SUBJECT: Discusses SEP Topics II-3.B, "Flooding Potential," II-3.B.1, II-3.c & III-3.c & NRC conclusion that util should provide protection from flooding of Deer Creek. NUS Corp std project flood peak analysis concludes site adequately protected.

Subject: SEP Topics II-3.B, II-3.B.1, II-3.C, III-3.C,
"Flooding Potential - Deer Creek"
R. E. Ginna Nuclear Power Plant
Docket No. 50-244

GINNA STATION STANDARD PROJECT FLOODING STUDY

Figure 7. Location of Cross-sections Used for Backwater Calculations

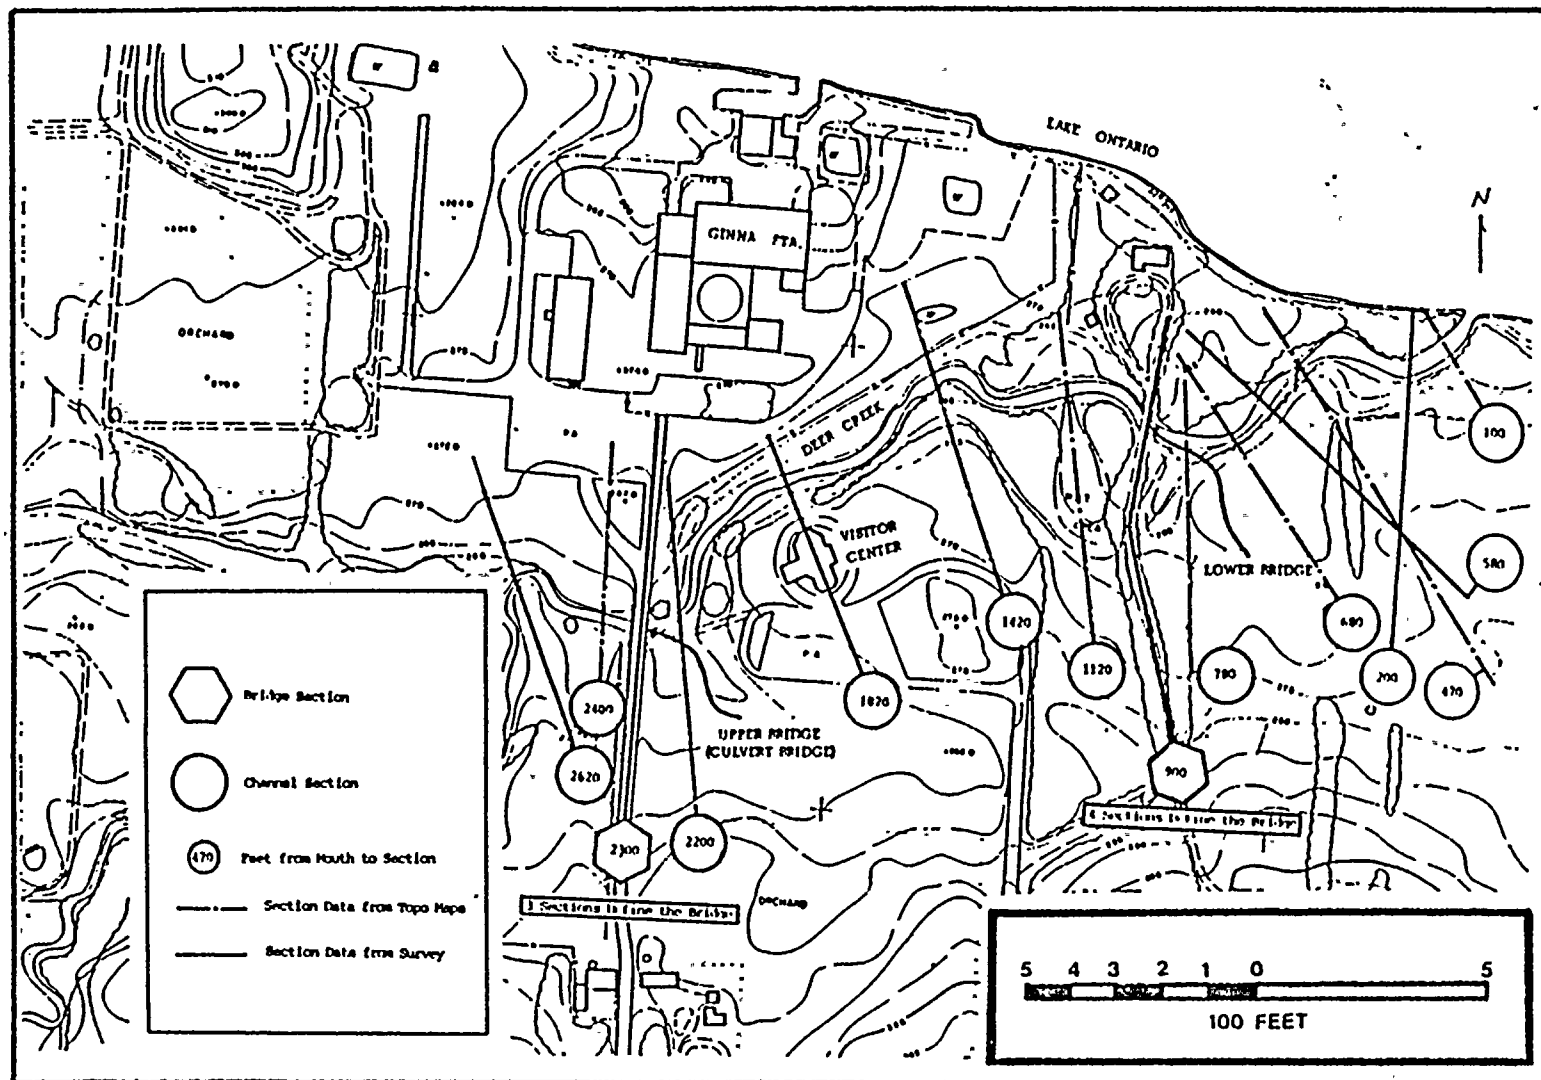
A further difference between the analyses is the FRC choice of constant over-bank and channel Manning's Coefficients for the entire creek length. This contrasts with the varying coefficients used in this report, and described elsewhere,⁽²⁾ which are based on direct observations of the basin. It is of note that no mention of FRC's modeling of the reach transitions and bridge constrictions is given. Assuming that they considered these effects in the same way as we, and using the SPF and cross-sections of our study, the effect of the change in Manning's Coefficients is an increase in water surface elevation at the Culvert Bridge of approximately six inches, as shown in Table 2.

Figure 8. Return Periods for 6- and 24-hour Rainfalls

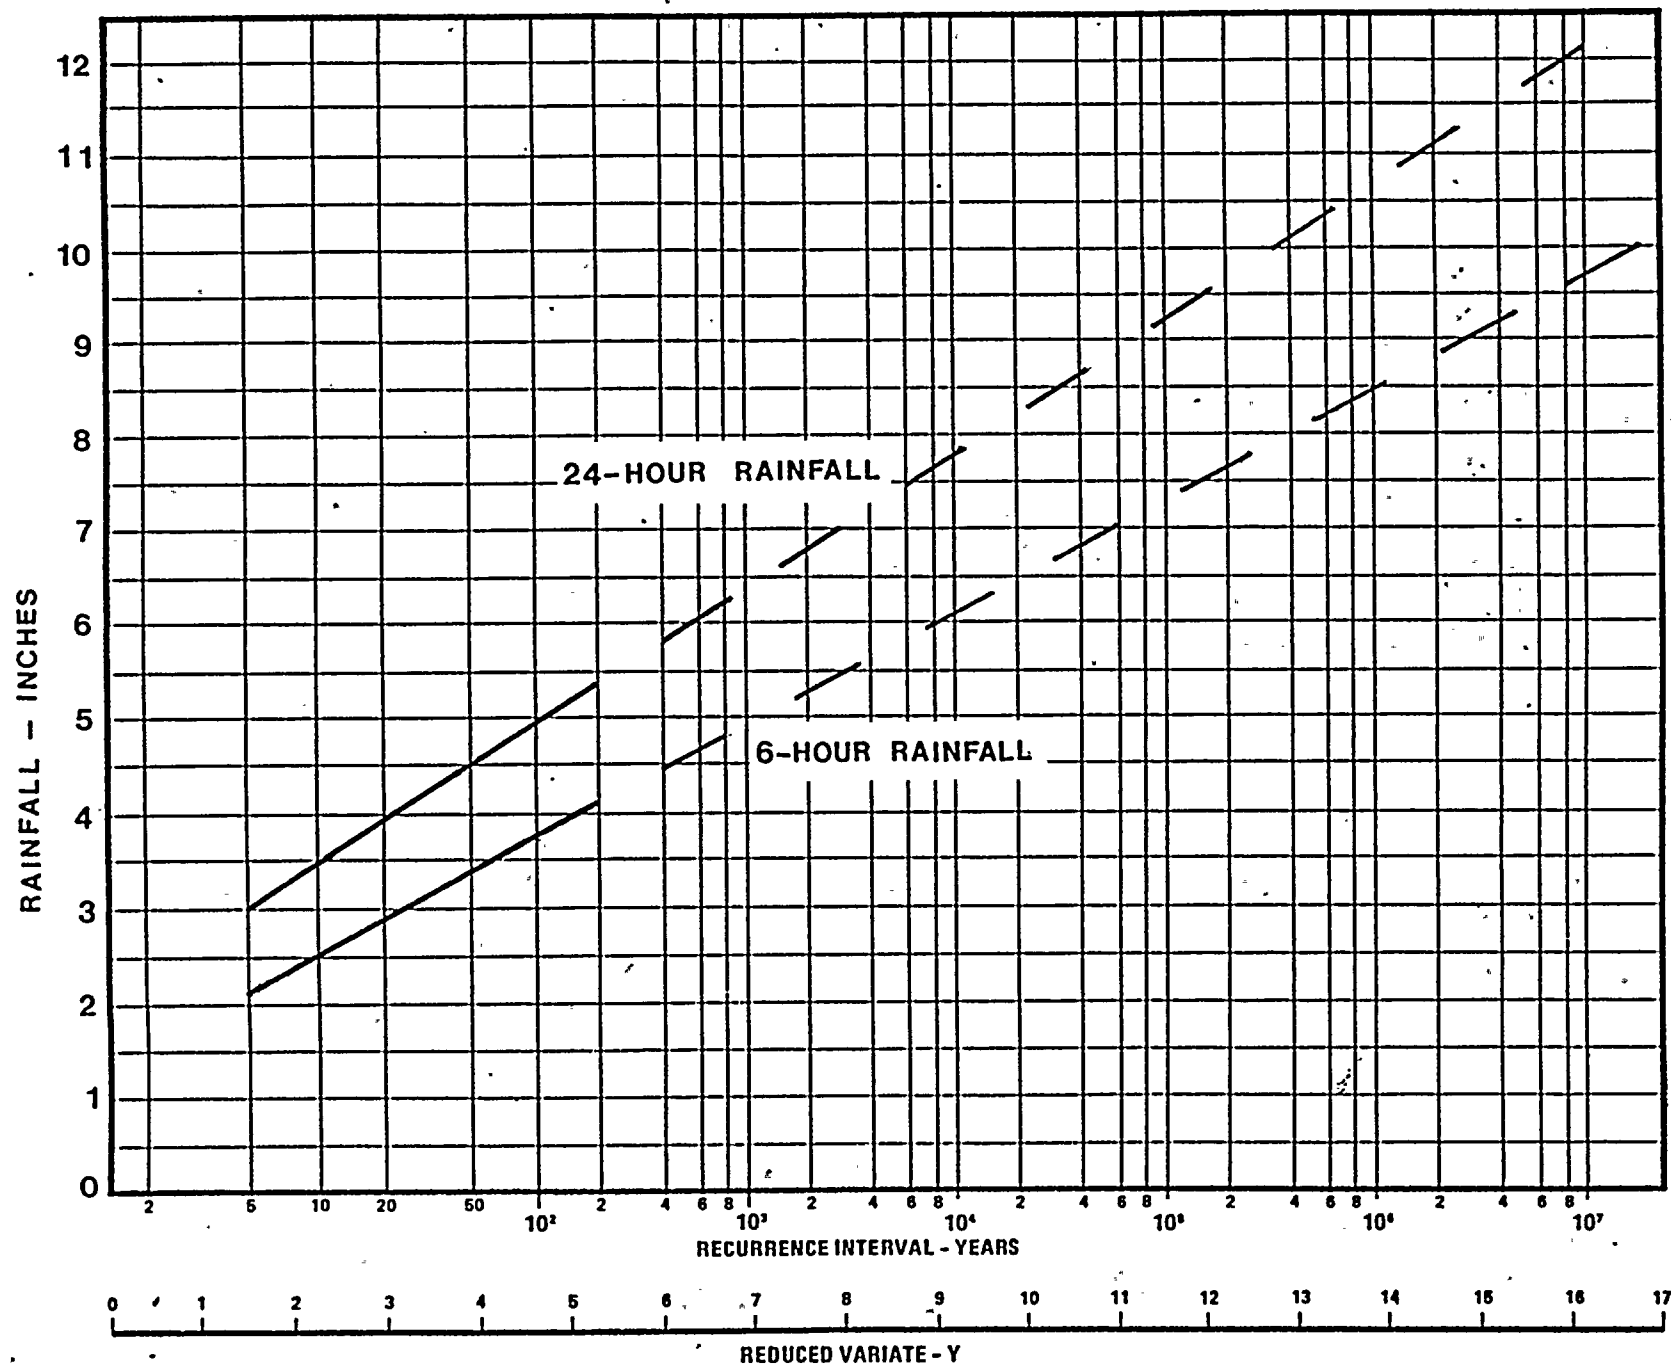
FRC chose a 9-inch 6-hour storm as the SPS. We are not quite sure how this value was obtained, the 6-hour storm not being explicitly given in the document describing Standard Project Floods.⁽³⁾ We do note that the probability of this storm is equivalent to the 11.2-inch 24-hour storm, as shown in Figure 8 (derived from information in reference 7). (This equivalence gives further credence to the efficacy of extrapolating the probability of occurrence.) Using all of the parameters and methodology described previously in this report, the peak discharge for the 6-hour SPS (9 inches) was calculated as 12,895 cfs. This value is comparable to the 13,092 cfs peak discharge for the 24-hour SPS (11.2 inches). Another major difference between these reports is FRC's choice of antecedent moisture condition III. Such a condition occurs, "when heavy rainfall or light rainfall and low temperatures have occurred during the 5 days previous to the given storm, and the soil is nearly saturated."⁽⁵⁾ Although AMC III is certainly more conservative than AMC II, (average case for annual floods) its utilization with the SPS is questionable, having the effect of making a low probability event even more improbable. This decrease in probability can't be strictly quantified; nevertheless a factor of 10 seems reasonable (this is the approximate decrease corresponding to an increase in precipitation equivalent to the increase in runoff from the SPS for a change from AMC II to AMC III). The effect of the AMC choice is illustrated by considering the SPF with AMC II (CN=85), AMC III (CN=94), and total precipitation runoff (CN=100), resulting in peak discharges of 13,092, 13,914, and 14,112 cfs, respectively.
